1803 Rhode Island Ave, NE Washington DC

REVISED DESIGN (2022)

Board of Zoning Adjustment
District of Columbia
CASE NO. 2021-14
ST-EX-18-013
upwall

Cellar Floor Level

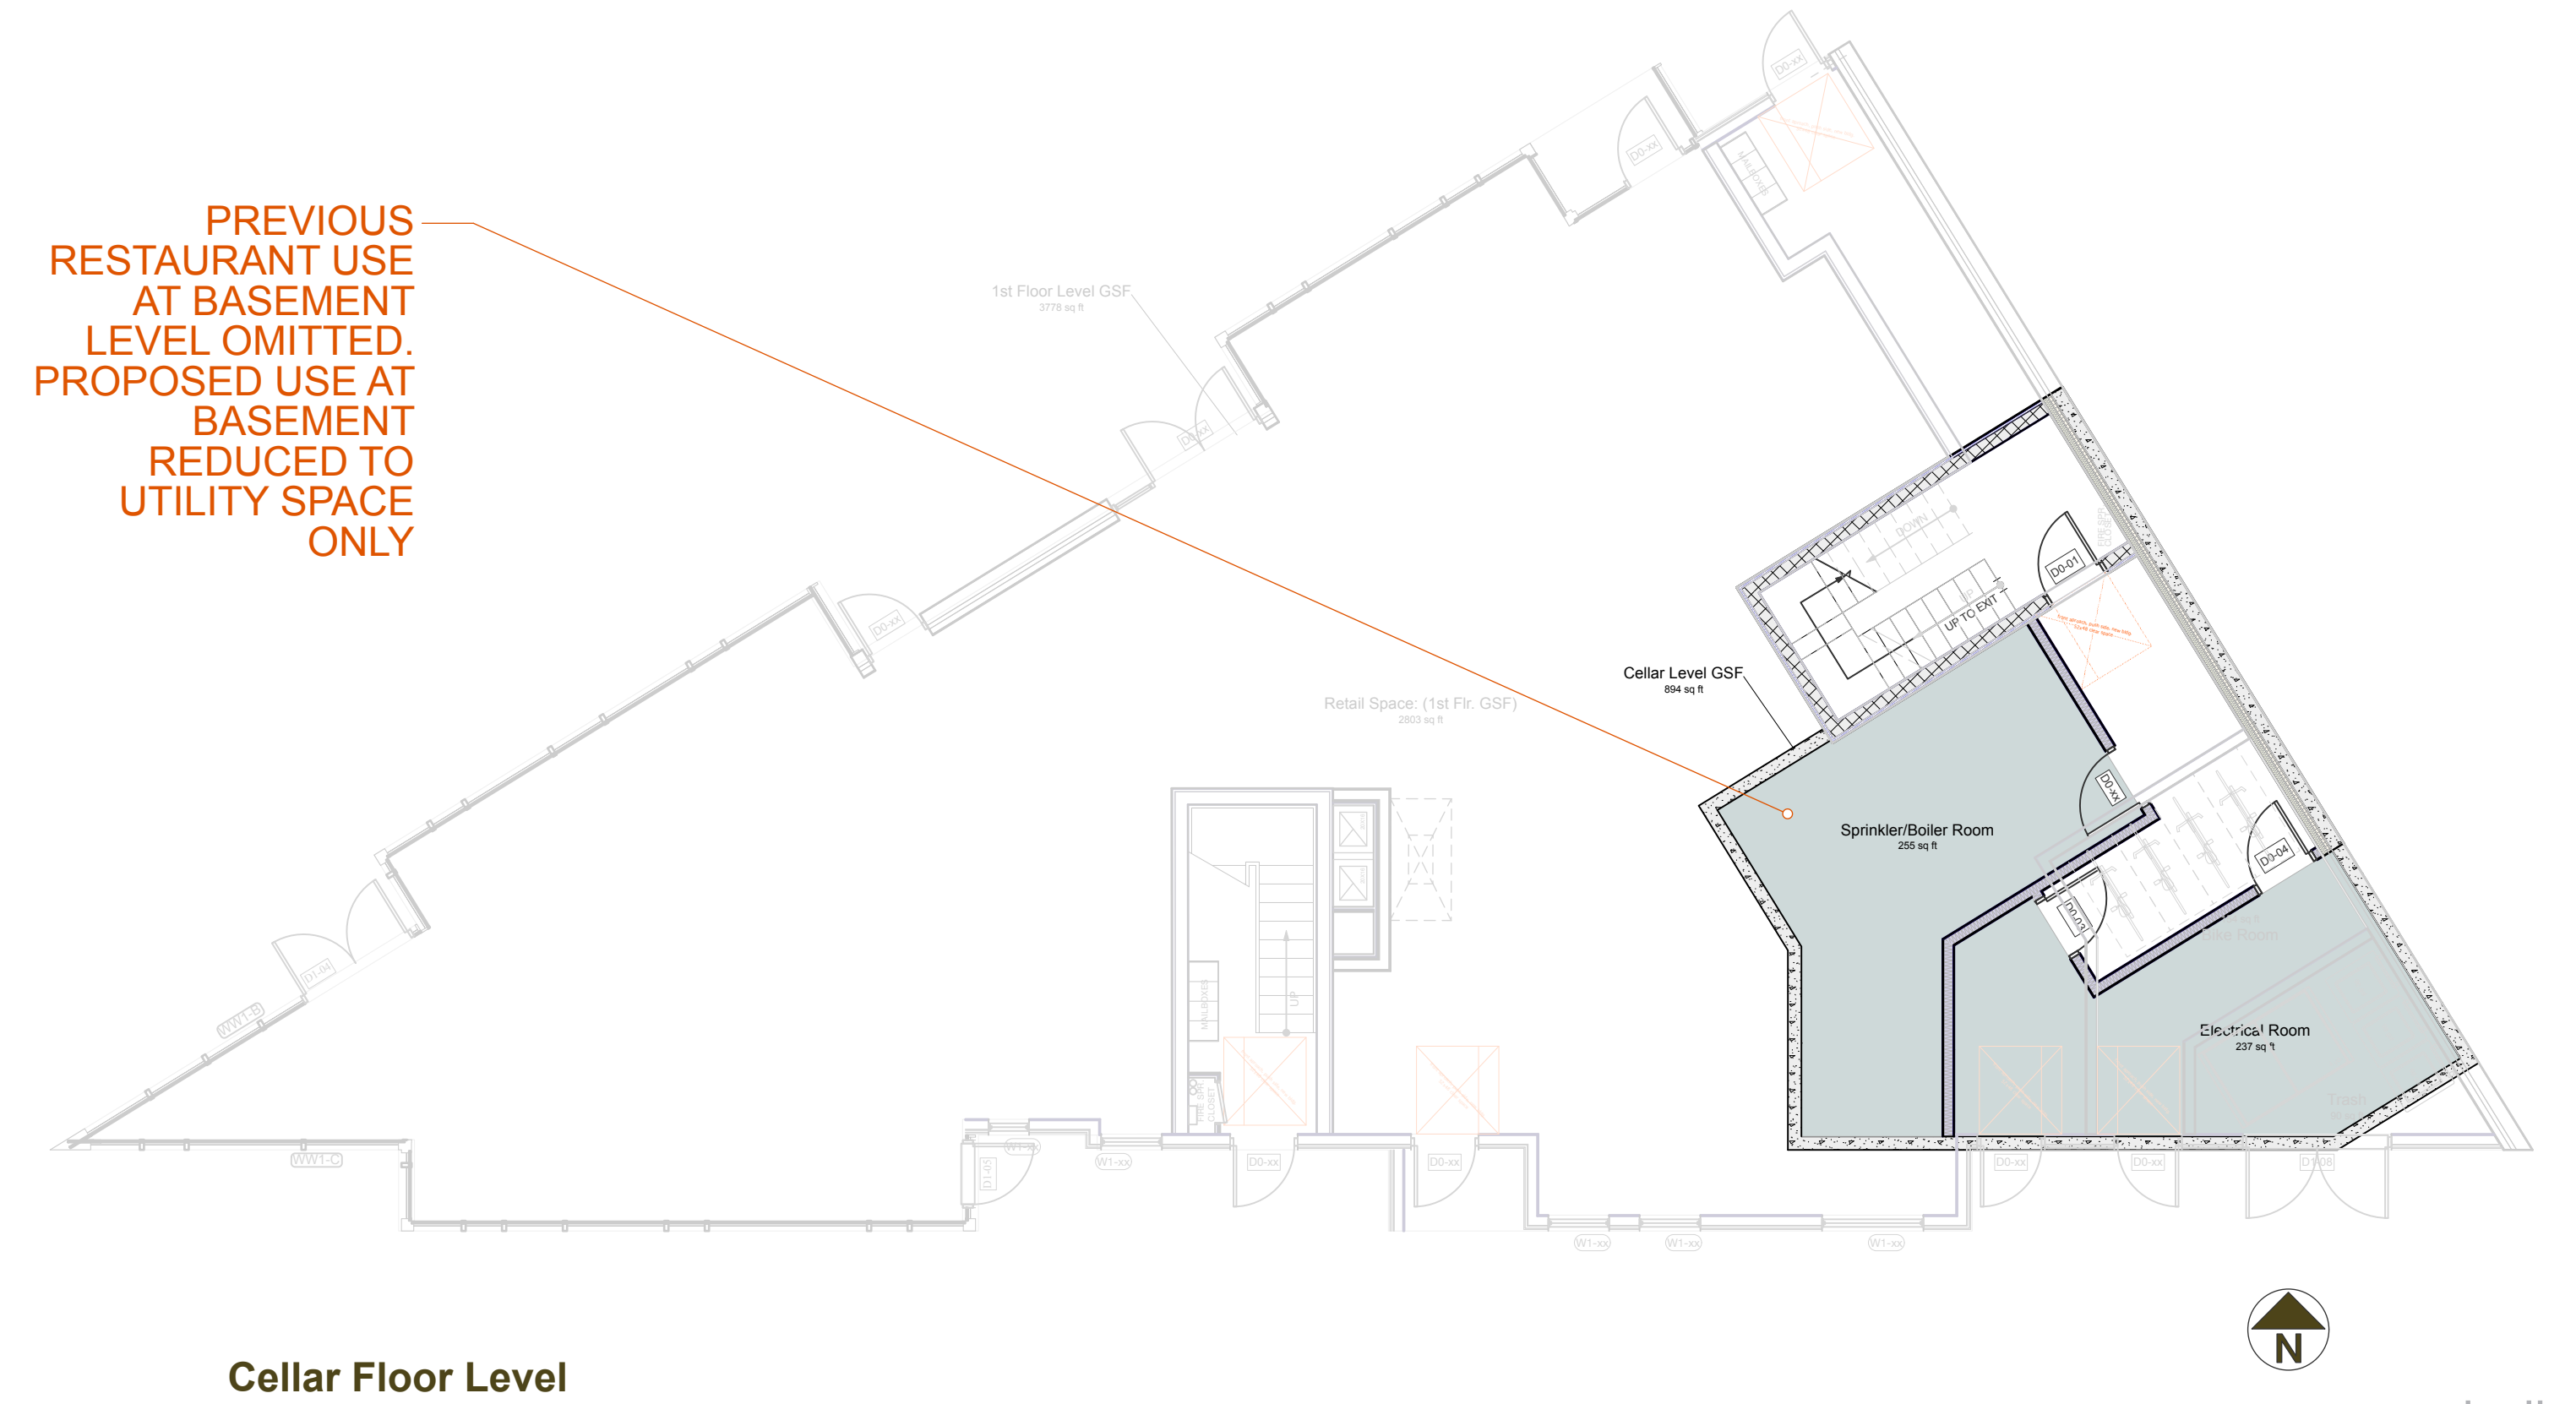
08.02.22 - (revised design)

2nd Floor Level

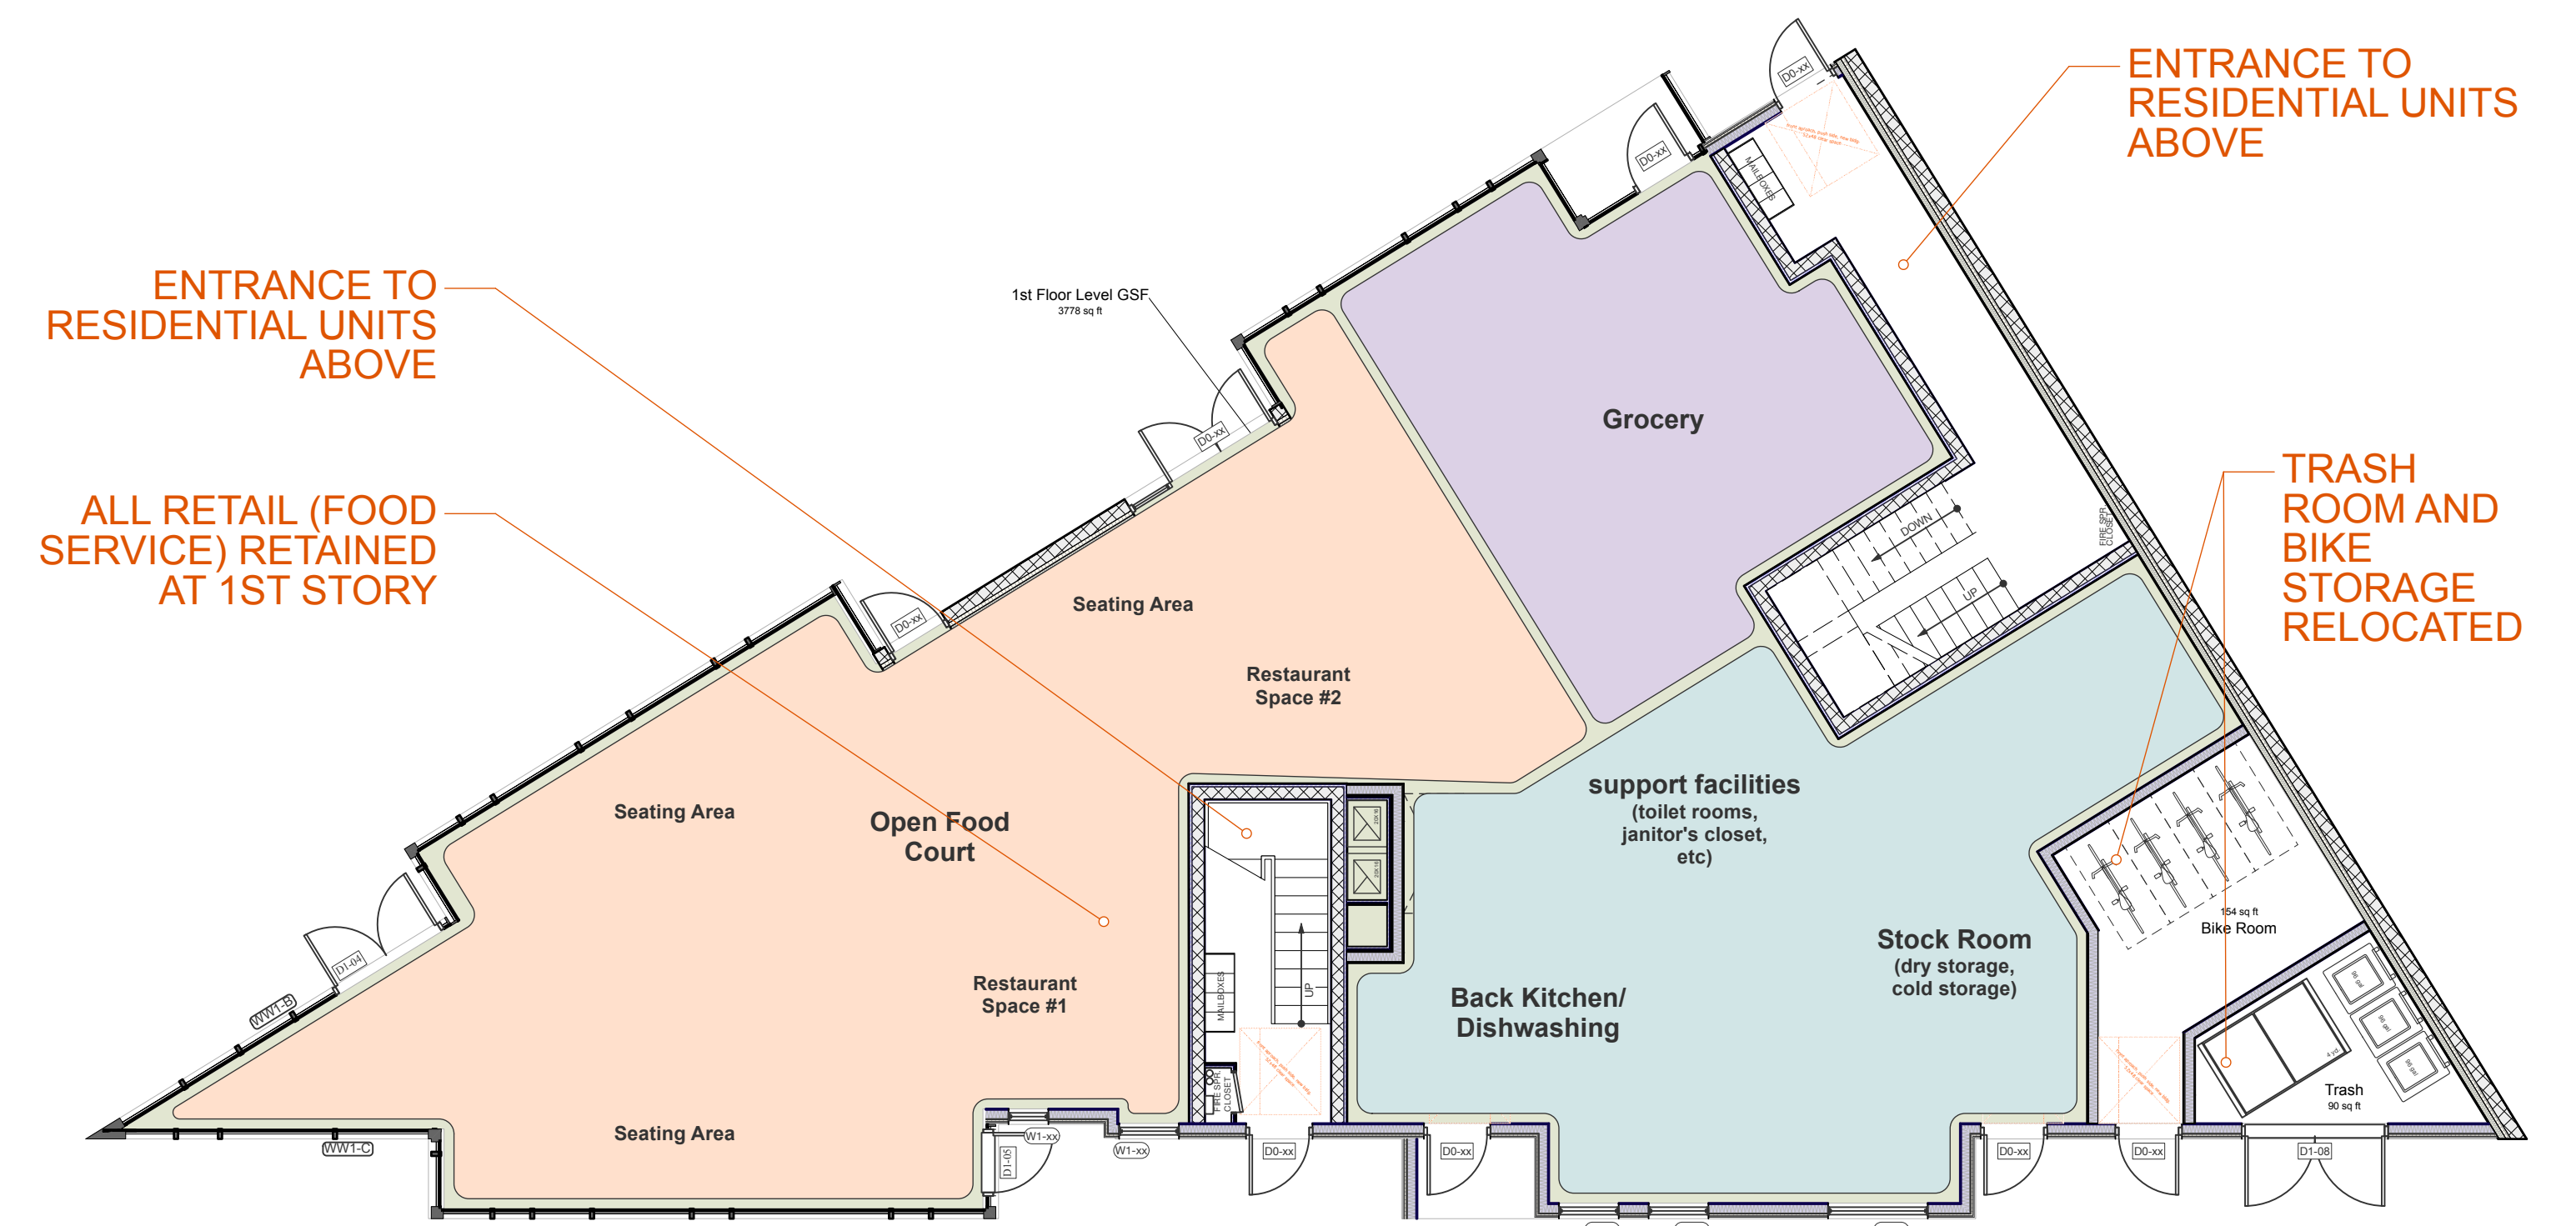
PROPOSED USE AT 2ND STORY CHANGED FROM RESTAURANT & RETAIL SPACE TO (4) RESIDENTIAL UNITS

STAIRWAY SERVING RESIDENTIAL UNITS
